Product Change Notice (IMS-TMP024_1)

iPCN000019 / Product Change Notice / 21/08/2026

iPCN Number	iPCN000019
Type of Notification	Product Change Notice

CamdenBoss wishes to inform you that the item(s) listed below have been changed.

Photo 1

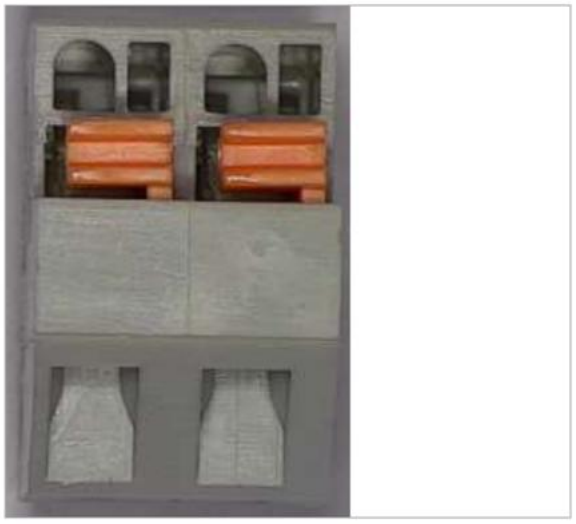
- Geometric cutouts changed as per attached image.
- Raw Material changed from PA6/66 to PA66, information attached.
- Improvement of performance as per attached table.
